RECORD OF ACTION

Planning & Zoning Commission

**1. Dublin Village Apartments at PID: 273-009045
22-163CP**

Concept Plan

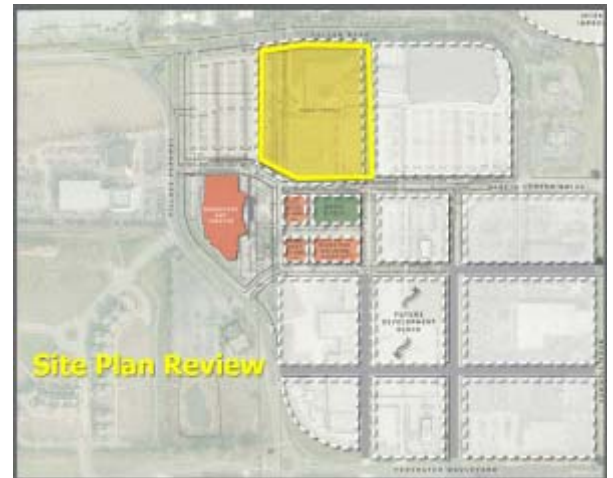
The project elements in the Development Plan Basic Plan Review include the proposed street network, block layout and dimensions, and consistency with the Sawmill Center Neighborhood District Standards. None of the developments shown on the interiors of the proposed blocks A, C, D, and E are included in the Development Plan Review (refer to Attachment A, Block Labels). Refer to the green highlighted areas on the top image to the right.

The project elements reviewed as part of the Basic Plan (Pre-Site Plan) Review include the proposed use, building type, site development, and the provision of open spaces. Refer to the yellow highlighted area on the bottom image to the right.

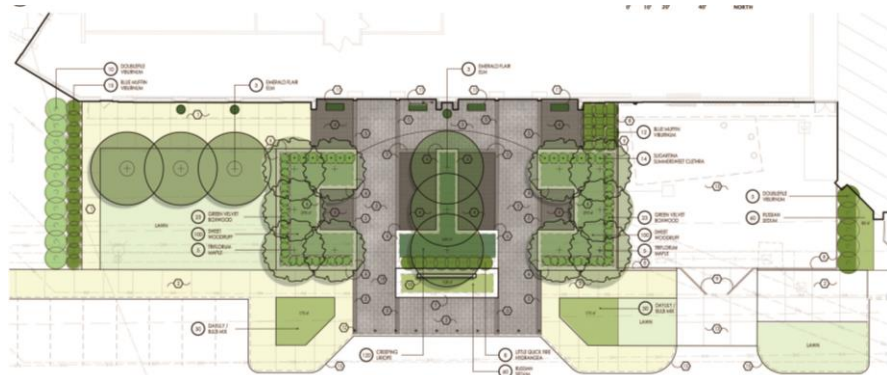
This is a request for review and approval of façade and site improvements for the rear of an existing building in the Dublin Village Center shopping center. The applicant is proposing a new storefront system on the west façade of northernmost building of the shopping center, with additional site improvements and landscaping to compliment the storefront addition. The improvements will accommodate a single tenant or multiple smaller tenants. The applicant has indicated that the modifications are intended to align with the goals of the Bridge Street District by activating buildings fronting along public right-of-way.

The applicant is proposing to replace 154 linear feet of an existing EIFS façade with a new storefront system. The improvement from a blank façade to a storefront façade brings the building closer to conformance with the BSD Code. The storefront is proposed to be an aluminum system in a 'Night Hawk Gray' finish with clear glazing windows between the frames. The storefront system will create nine openings where up to two tenant spaces may be included. The coping surrounding the storefront system will be prefinished metal in a 'Champagne' finish. In areas where the new storefront system is not proposed, the applicant is proposing a Nichiha horizontal panel material in a 'Bark' finish to serve as a backdrop for the new tenant spaces. Nichiha, a cementitious material, is a permitted secondary material within the Bridge Street District. The applicant should work with Staff to verify that the cementitious material does not exceed 20% of the entire west façade of the building. The remainder of the façade within the scope of this project will be painted EIFS in an 'Urbane Bronze' finish. Finally, the applicant is proposing a thin set 'Buffstone' watertable below the installation of the horizontal panels. The applicant will be painting the remainder of the existing EIFS, doors, and utilities not within the scope of the storefront improvements in a 'Pussywillow' (Gray) color. New light fixtures are proposed to accent the building and be compatible with the overall shopping center. The applicant should work with Staff to finalize the lighting selection, subject to Staff approval, prior to building permit submittal.
